Subject: MHI's Response to US-APWR DCD RAI No. 921-6415 Revision 0 (SRP 06.02.02)

Response to Request for Additional Information No. 921-6415
Revision 0

**US-APWR Design Certification
Mitsubishi Heavy Industries, Ltd.
Docket No. 52-021**

RAI NO.: NO. 921-6415 REVISION 0
SRP SECTION: 06.02.02 – Containment Heat Removal System
APPLICATION SECTION: 6.2
DATE OF RAI ISSUE: 4/16 /2012

Figure 1: Plan View in Reactor Cavity around Overflow Pipes

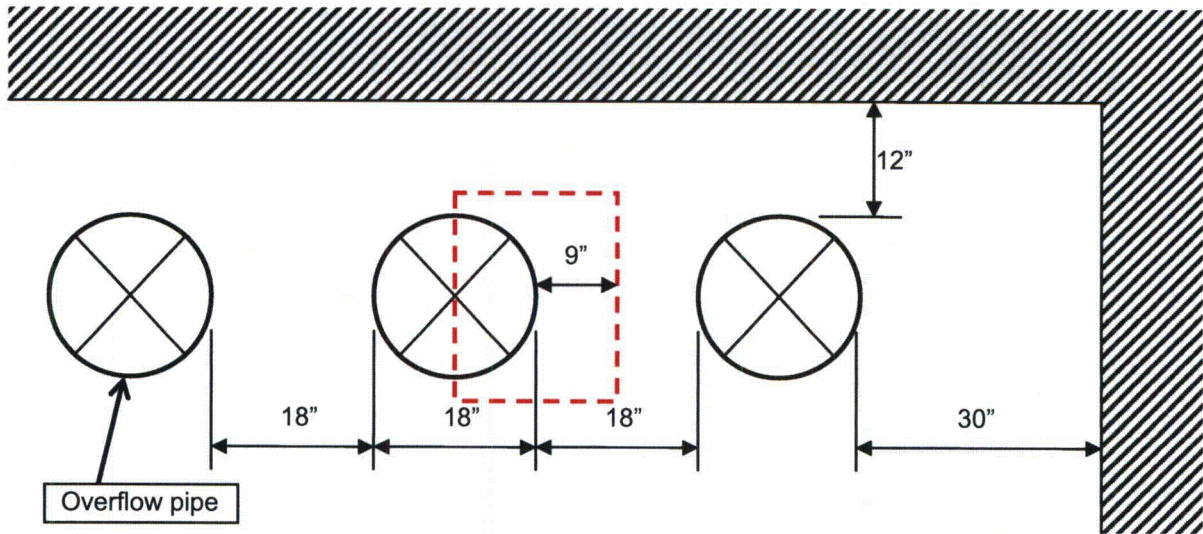
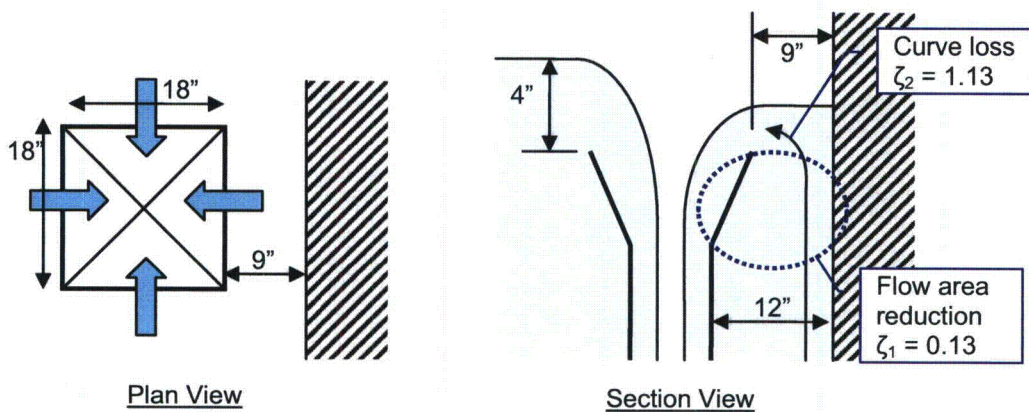
The water level (hold-up) analysis for each set (three total) of four overflow pipes did not address the arrangement of the overflow pipes and their proximity to each other (within a set) and structures. Therefore, it appears each pipe is treated as an individual pipe that is not influenced by neighboring pipes/structures. Provide an assessment of each set of four overflow pipes that justifies their treatment as individual pipes/circular weirs, taking into account their arrangement with each other and structures, or explain how this uncertainty is accounted for in the water hold-up analysis.

Basically, MHI believes the effect of adjacent piping and walls is very small because the flow-field difference is small as described in the response to Question No. 06.02.02-72 of Reference 1. The difference is that the flow comes from two dimensions in the response in Reference 1, but in this case flow comes from three dimensions and the flow velocity becomes very low compared to the two dimensional flow.

As described in the response in Reference 1, the overflow height will be 4.1 in., but in order to consider uncertainties for the overflow piping such as the proximity effect, etc., a 20% blockage of the overflow piping was assumed resulting in a calculated overflow height of 4.92 in. Since 5 in. was used for the hold-up water volume calculation, the proximity effect is included in the conservativeness of the overflow height actually used in the hold-up volume calculation.

To evaluate the proximity effect, the red-dashed area in Figure 1 (the narrowest point) is conservatively modeled as shown in Figure 2. The following simplified assumptions were also applied:

1. Assume the overflow piping as a square as shown in Figure 2.

2. Consider the pressure loss of the flow area reduction and curve loss as shown in Figure 2.
3. Assume the loss coefficient of flow area reduction, $\zeta_1 = 0.13$, and the curve loss, $\zeta_2 = 1.13$.
4. Flow rate coming to one side is $0.021 \text{ m}^3/\text{sec}$ ($= 1.01 \text{ m}^3/\text{sec} / 12 \text{ pipes} / 4 \text{ sides}$).

Thus the total pressure loss becomes 0.0056 m (0.22 in.).

Summarizing the discussion, there is 0.9 in. margin for the overflow height calculation and the proximity effect is only 0.22 in. Therefore, the proximity effect is sufficiently bounded by the existing conservativeness.
